**Sandyford Business District
Cycle Infrastructure Review**

Issues at Junctions

P18-055-DG-003

Blackthorn Drive/Benildus Avenue Signalised Junction

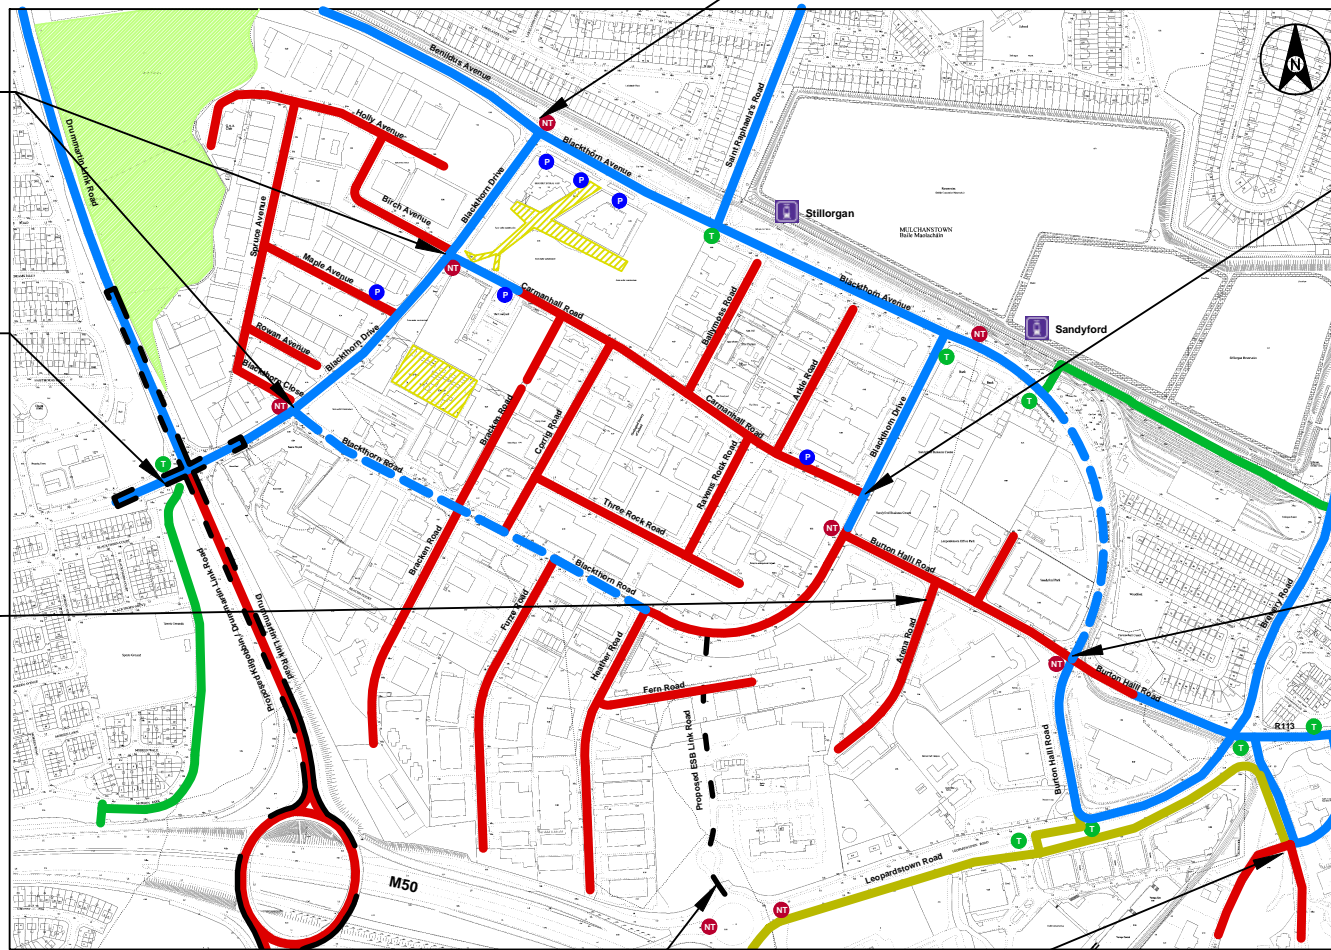
Priority 2: Issue 1
No signal for right turning cyclist.
Recommendation
Provide signal phase and a detector loop for right turning cyclists.

Priority 2: Issue 2
Cyclists travelling west on Blackthorn Drive must move into running carriageway as a result of island located within cycle path.
Recommendation
Set back the island providing continuous cycle facilities through the junction.
